Subject: Calico Solar 08-AFC-13C  
Applicant's Response to CEC Data Requests Set 1 (1-37)

## Applicant's Response to CEC Data Requests Set 1 (1-37)

CALICO SOLAR PROJECT

**Calico Solar**  
**Responses to CEC Data Requests**  
**Data Request Set 1 - Requests 1-37**  
**08-AFC-13C**

**SWR-6**

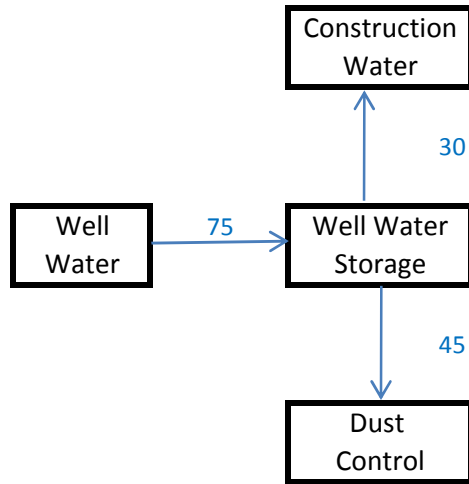
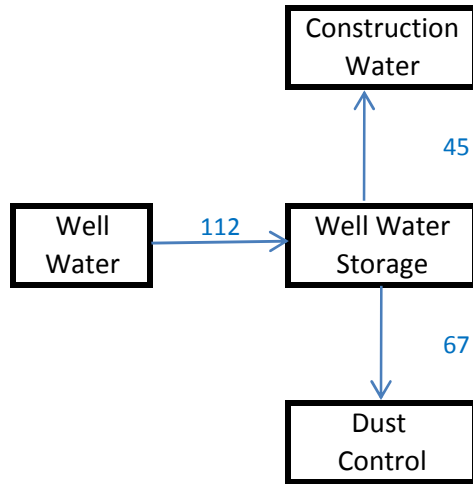
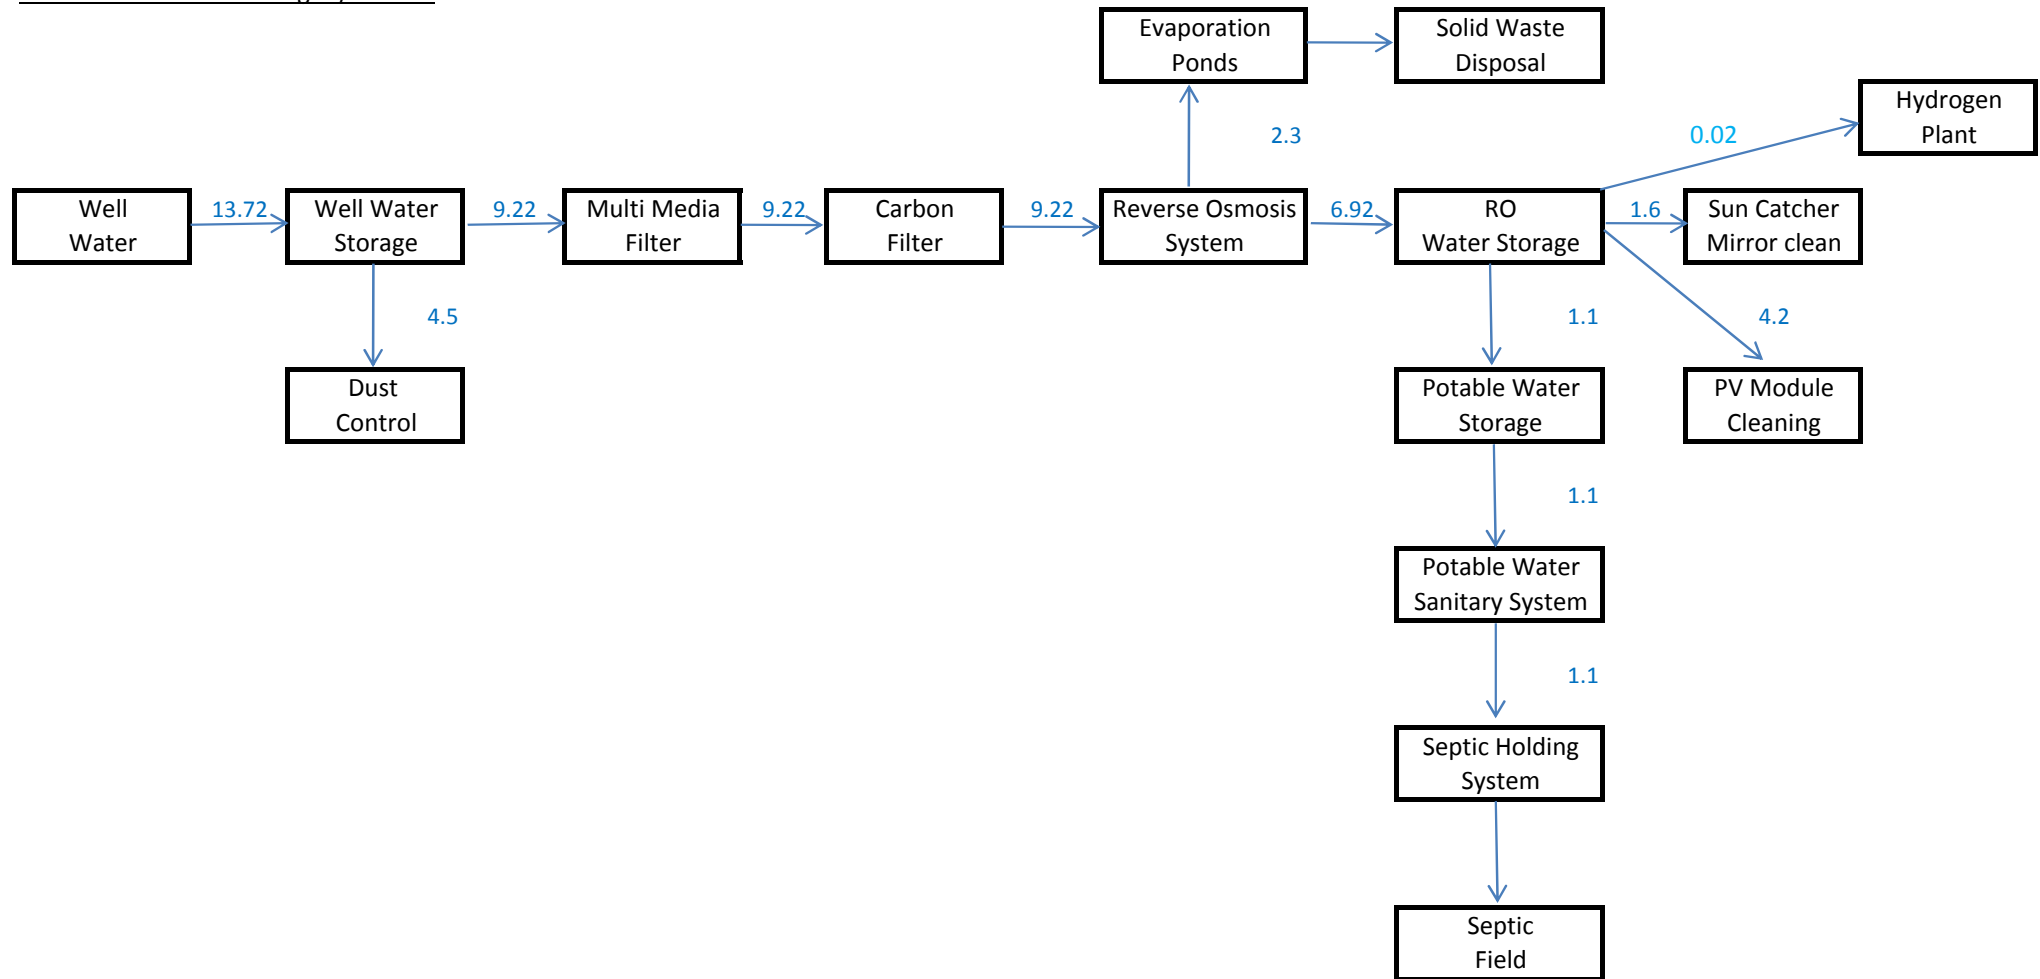
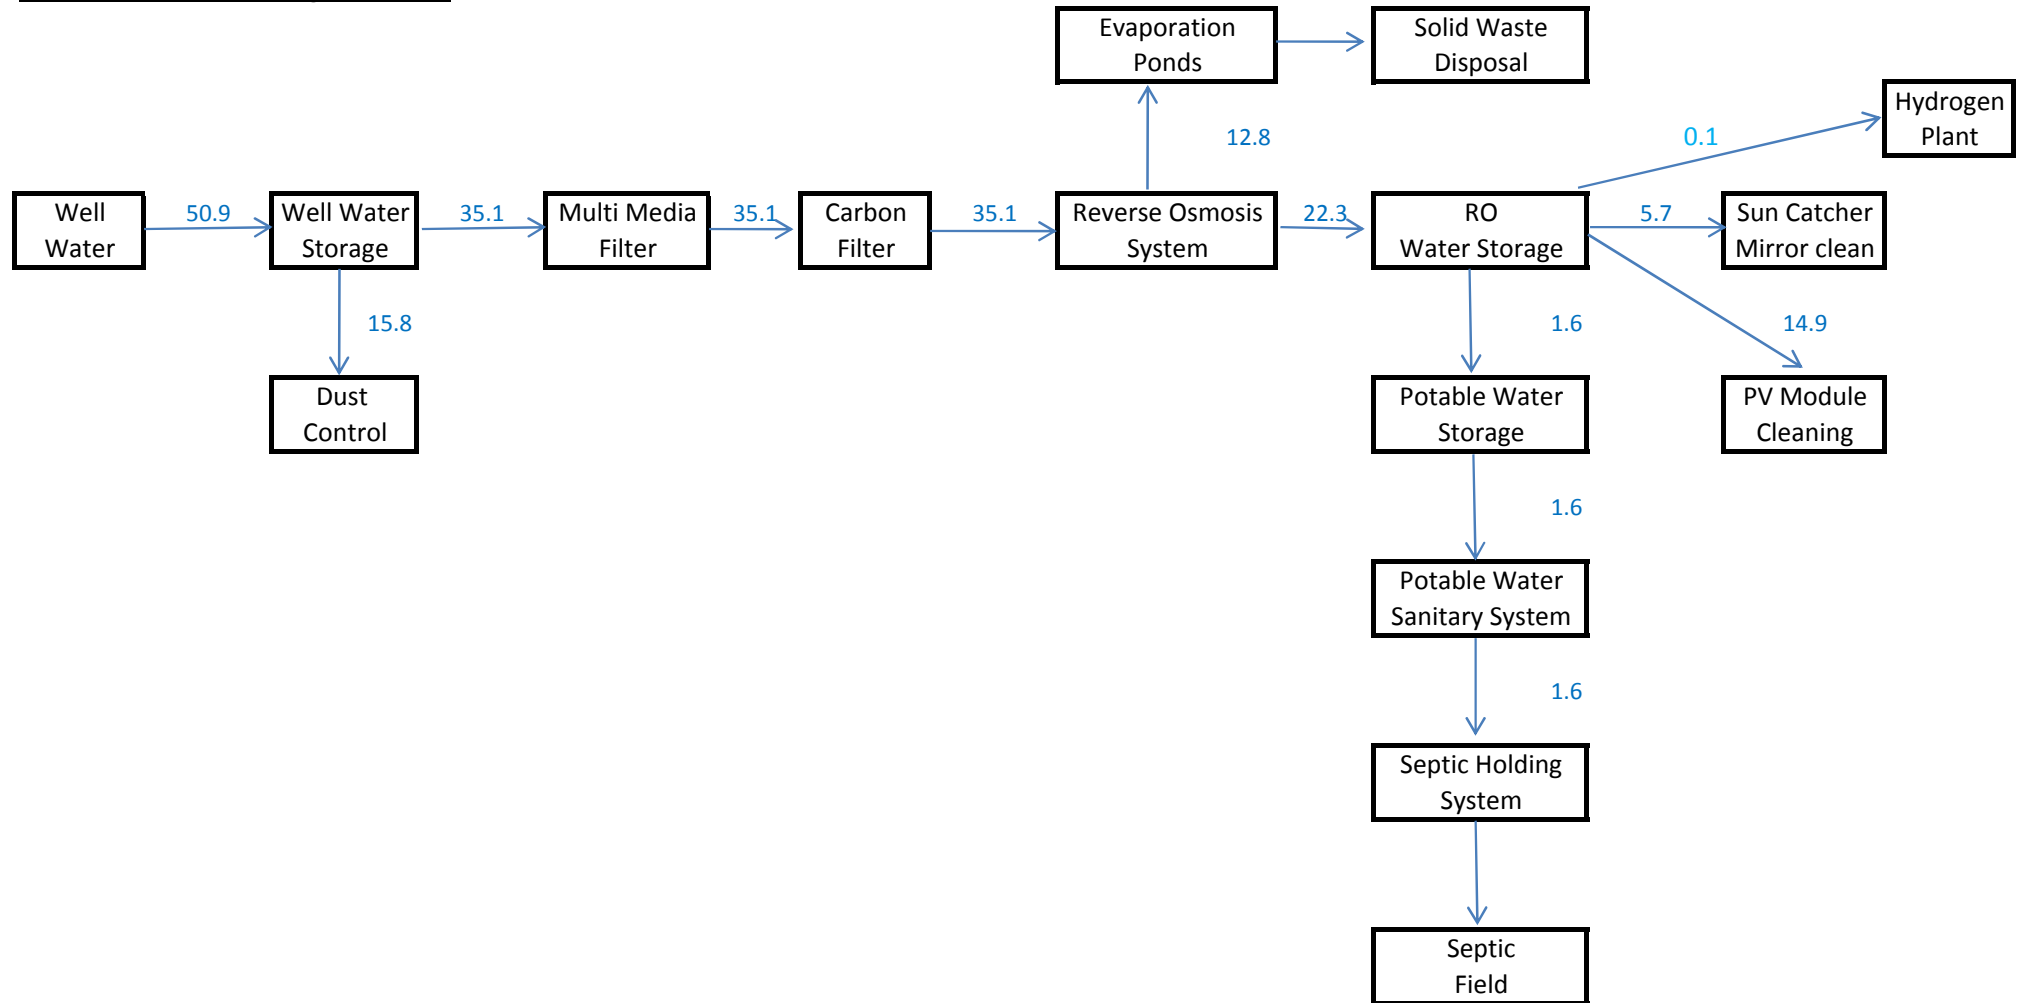
Please revise the Construction Water Balances provided in Appendix D to be specific to construction of the Modified Project. If these revisions result in a change in expected construction water use, please revise construction and operation water use tables accordingly.

**Response:** Revised construction and operation water balances are provided as attachments SWR-5 and SWR-6, respectively. The values in the water balances are consistent with the values presented in the tables provided in response to Data Requests 16 and 17.

Graph 1 - Common Spectral Surfaces  
Source: SunPower

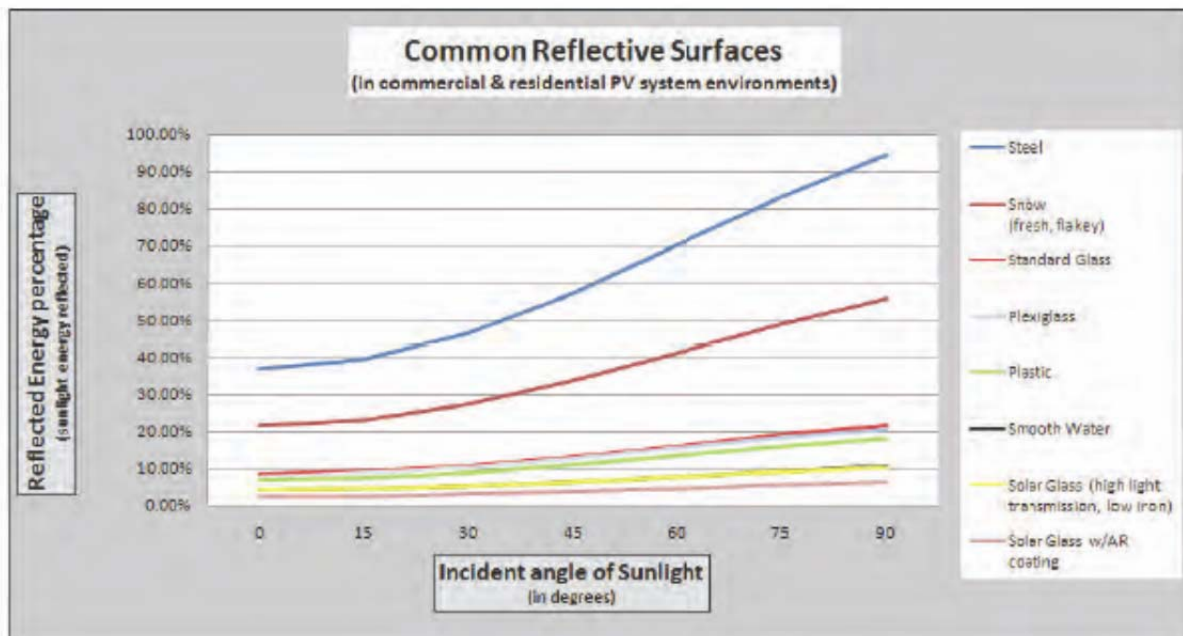
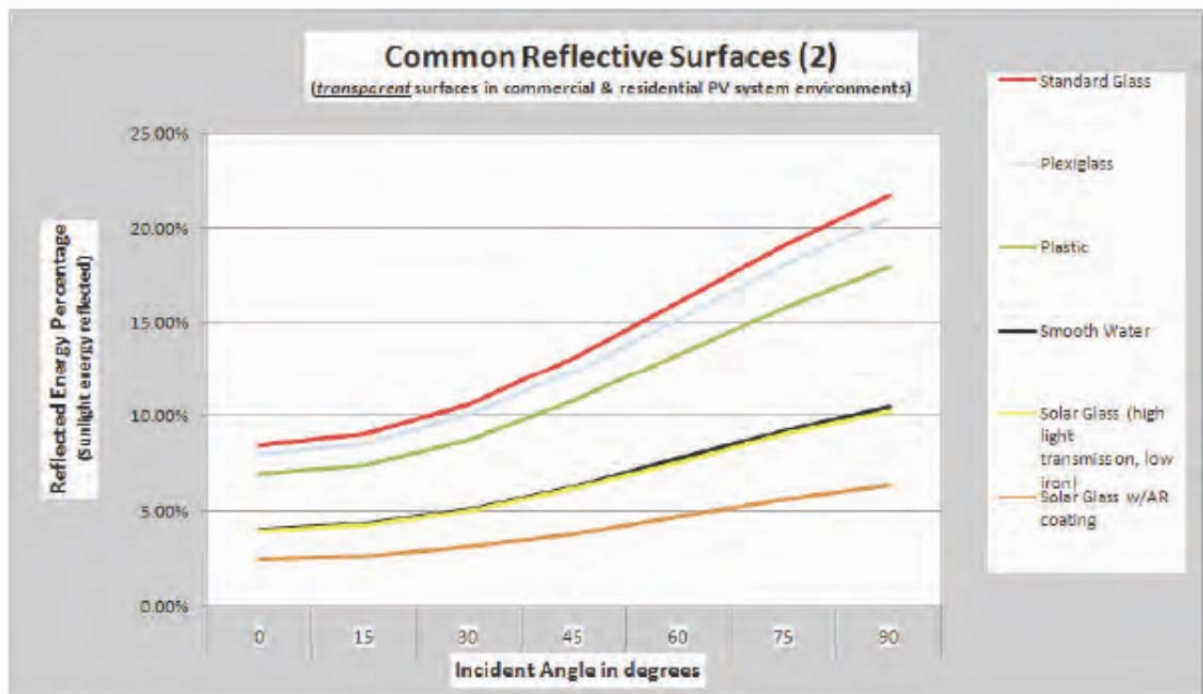
- a. Staff requests that this discussion be expanded to substantiate the analysis, including a citation(s) and reference(s) for applicable completed studies addressing the same or similar technologies.
- b. Staff also requests that the discussion and conclusion at the bottom of page 4.13-5 be rewritten using standard CEQA terminology. In other words, please revise the discussion to clearly state the impact conclusion (e.g., potentially significant impact), and refer to applicable conditions of certification that would reduce the impact to a less-than-significant level. Include evidence to support the conclusion.

- a. Most solar glass sheets (the glass layer that covers the PV modules) are typically tempered glass that is treated with an anti-reflective or diffusion coating that further diffuses (scatters) the intensity of glint and glare produced (County of Kern, 2010). In general, because the concept of efficient PV solar power is to absorb as much light as possible, standard PV modules produce less glint and glare than standard window glass (Powers Engineers, 2010). As is shown in the SunPower Corporation charts that are presented below, the reflected energy percentage of solar glass is far lower than steel, snow, standard glass, plexiglass, plastic, and smooth water. Conversely, the intent of the mirrors contained within SunCatchers is to reflect as much light as possible. A glint and glare study was performed specifically for SunCatcher technology (Powers Engineers, 2010). The study cited glint and glare concern from energy reflecting from the mirrored surfaces rather than the other SunCatcher components, implicitly indicating a lower potential for glint and glare from the steel components of the SunCatcher than the mirrors. As represented by the charts below, PV glass has a lower reflected energy percentage than steel. Therefore, it is expected that glint and glare from PV technology would be lower than from SunCatcher. Because the Modified Project employs PV technology throughout the site, specifically in areas closest to viewers, impacts from glint

**VIS-2**

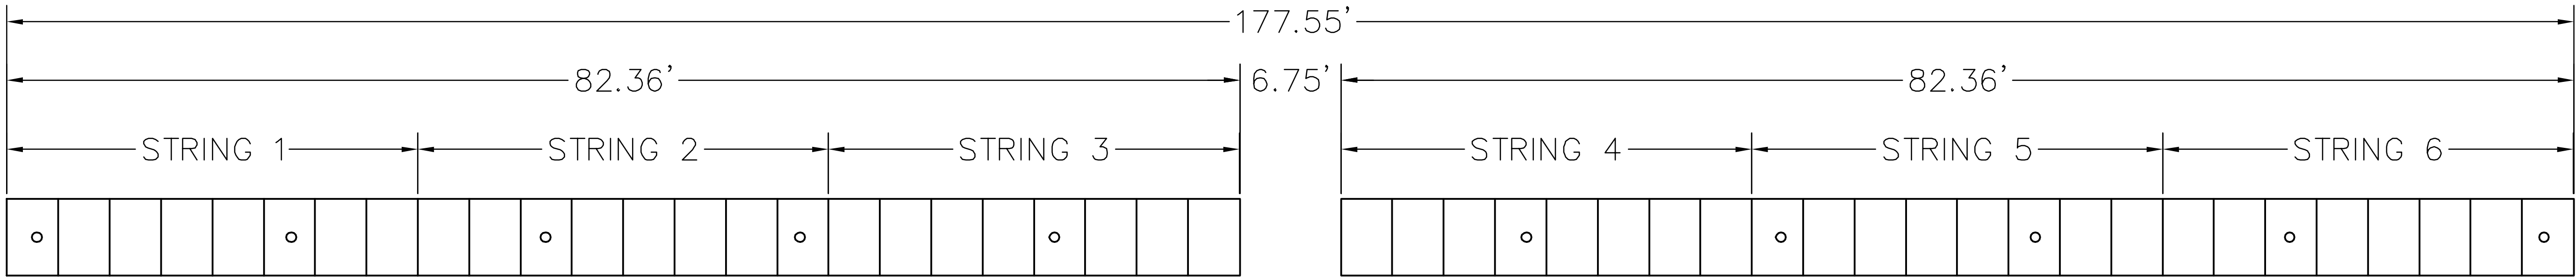
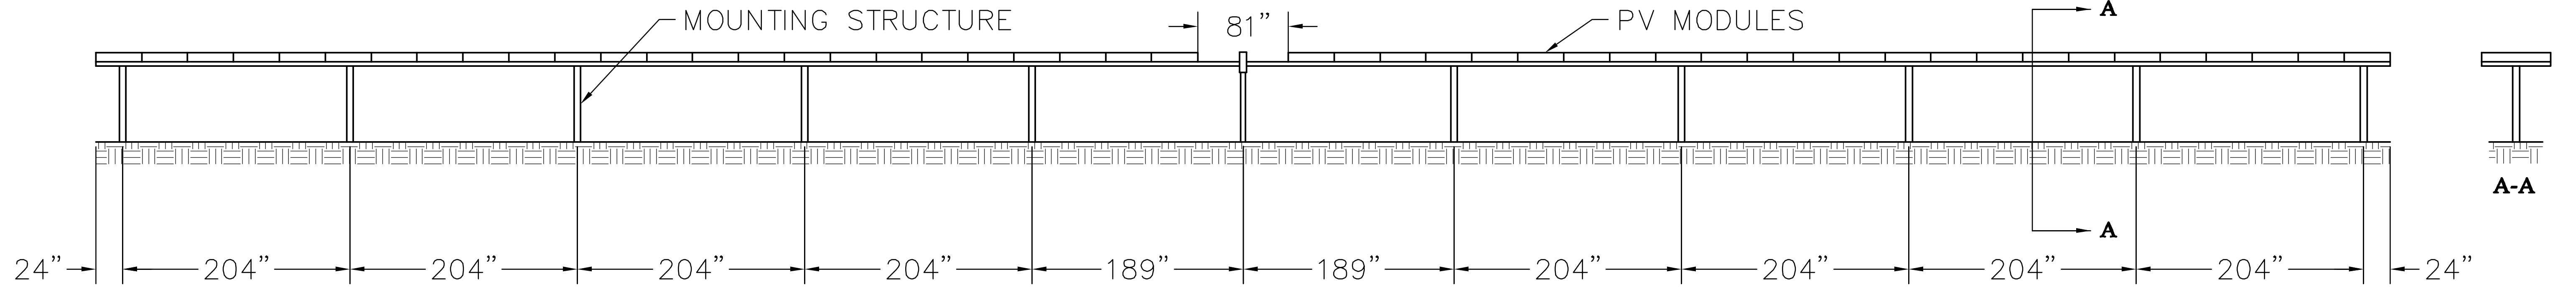
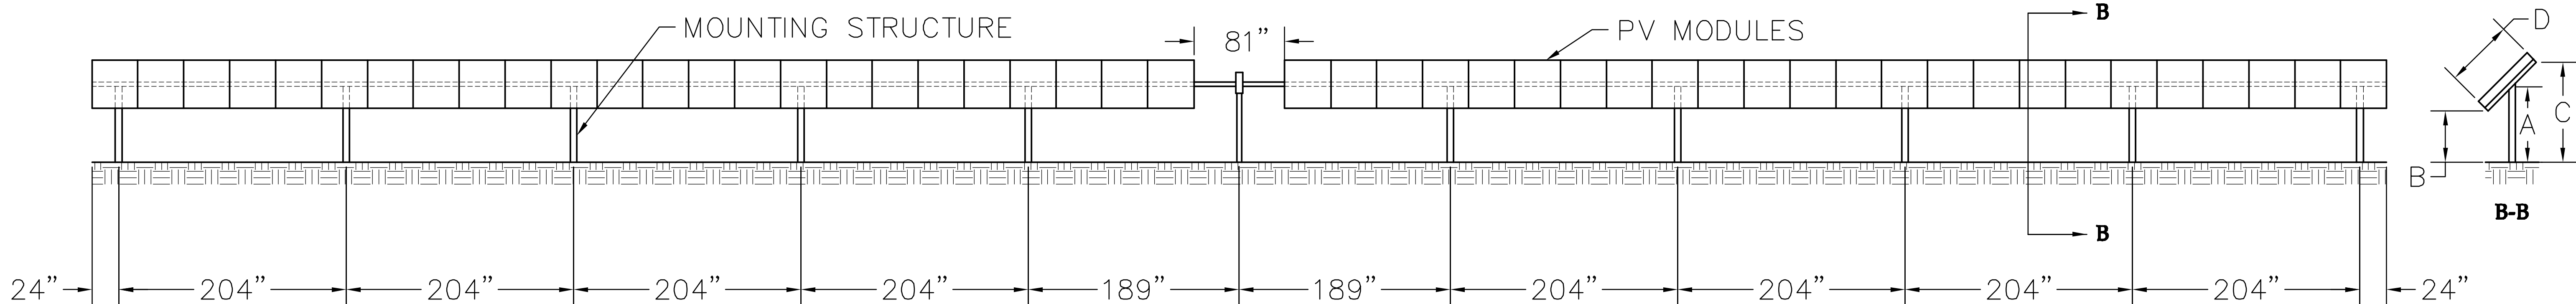
Please provide a scaled elevation drawing of a PV module and row of modules in front and side view with mounting structures. The drawing shall provide more detail than is shown in Figure 2-4 in the Project Description of the Petition to Amend. Please include a representative view of PV modules at maximum tilt, as well as representative photographs of the same or similar PV modules.

**Response:** Please see the included 2011-04-29 TYPICAL PV ROW provided as attachment VIS-2.
